Supplier Deviation Disposition Request

PROJECT: River Protection Project Waste Treatment Plant

FOR RPP-WTP USE		
RPP-WTP SDDR No. 24590-WTP-SDDR-MS-12-00039	Rev. N/A	DATE RECEIVED 02/29/12

Title of SDDR: Minor deviations to the motor specification and clarification for spare terminals

REFERENCE 4.2

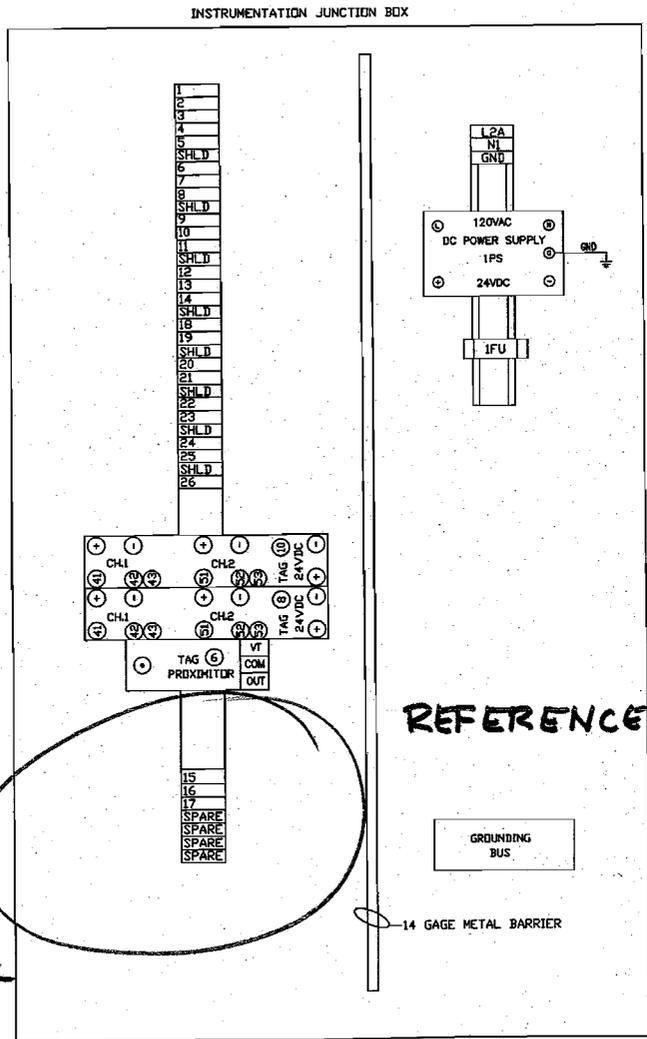
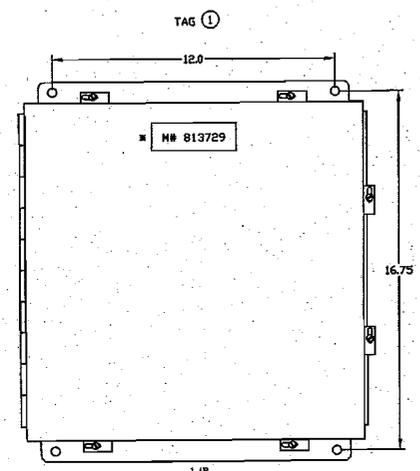
Reference 4:
24590-LAW-3PS-MACS-T0001 Rev 2, Sec 3.15.6, "Provide 10% spare terminals."
Deviation:
10% spare terminals are not evenly distributed.

- 3.15.6 Both temperature and speed wires shall be connected to terminal blocks provided by SELLER. Terminal blocks shall be installed in a separate electrical termination box for external connection to Buyer's cable(s). SELLER shall provide sufficient terminals to allow landing and continuation of conductor shields. Provide 10% spare terminals.

6. Supplier's Estimated Cost Impact: NONE	7. Supplier's Estimated Schedule Impact: NONE
<p>8. Proposed Disposition and Technical Justification (plus Cost/Schedule if applicable): (Attach extra sheets, sketches, etc., as necessary.)</p> <p>Reference 1: The motor base has been drilled and threaded for ground connection, obsoleting the need for a nut. A bolt is provided in combination with the threaded base, complete with washers.</p> <p>Reference 2: Due to precision balancing and alignment of the exhausters and motors, vertical alignment of the motors is custom-tuned for each exhauster assembly by use of precision shims, obsoleting the need for vertical jacking bolts. Because of the precision balancing and alignment required, the manufacturer recommends against using vertical jacking bolts as they may result in a "soft foot" condition, leading to premature equipment failure.</p> <p>Reference 3: Time Rating: Listed on the nameplate as "DUTY CONT" (continuous duty). Temperature Rise/Insulation Class: Listed on the nameplate as "INS CLASS H" (insulation class H). Code Letter for Locked-rotor kVA: Listed on the nameplate as "CODE G". Buyer's Driven Equipment Tag No: Not listed; since the motors are fabricated without knowledge of specific use and/or application, there is no way for the manufacturer to know customer-specific equipment tag numbers. Driven equipment tag numbers are easily located, as required, on the driven equipment attached to the motors. Type of Enclosure: Not listed; the "FRAME 447TS" listing is tied to a single enclosure type of Totally Enclosed, Fan Cooled (TEFC). Space Heater Voltage/Rating: Not listed; the space heaters are 120 VAC.</p> <p>Reference 4: Due to evolving project requirements and consultation with WTP, the signal current to the purge control panel pressure switches was decided to be 24 VDC. This decision required that these signal terminals occupy the limited number of available 24 VDC spares locations previously provided rather than using the surplus 120 VAC positions, reducing the available 24 VDC spare terminals to less than 10%. Total number of available Junction Box spare terminals (24 VDC and 120 VAC) remains at 10% spares.</p>

Engineering concurs with the suppliers disposition in blocks 4 & 8 of this form. Use As-is.
 References 1 to 4.2 attached for information.
 E&NS screening is required because the MR and affected specifications are Q.
